# REGIONAL REVIEW FINDING

ARC REVIEW CODE: R1907031

**Name of Proposal:** Lithonia Distribution Center (DRI 2961)

**Submitting Local Government:** City of Stonecrest

DRI SITE PLAN

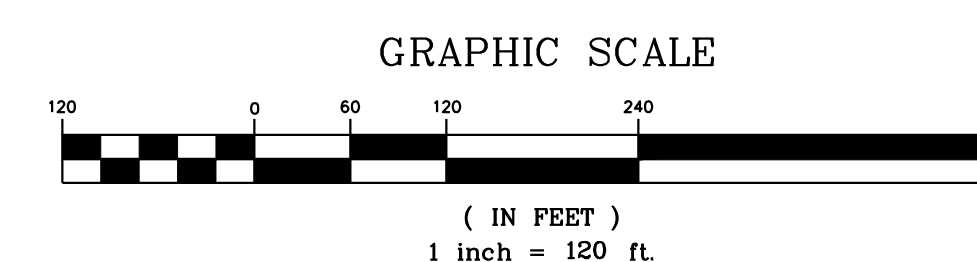
Both the submitted site plan and the USGS coverage for the project area show Swift Creek, a blue-line stream and tributary to the Yellow River, running through the western portion of the project property and along the northwestern side of the property, away from the proposed development. The submitted site plan also shows an unnamed tributary to Swift Creek and three unnamed tributaries along the eastern portion of the project property, close to the proposed development area. The site plan shows the County 75-foot stream buffer along all the streams shown on the property. Although the development shown comes to the edge of the buffer in places, no intrusion into the buffers is shown. Any unmapped streams on the property may also be subject to the requirements of the DeKalb County Stream Buffer Ordinance. The mapped streams, any unmapped streams and all waters of the state on the property are also subject to the State 25-foot Erosion and Sediment Control Buffer, which is not shown on these plans, but should be shown. Any intrusions into the buffers may require variances.
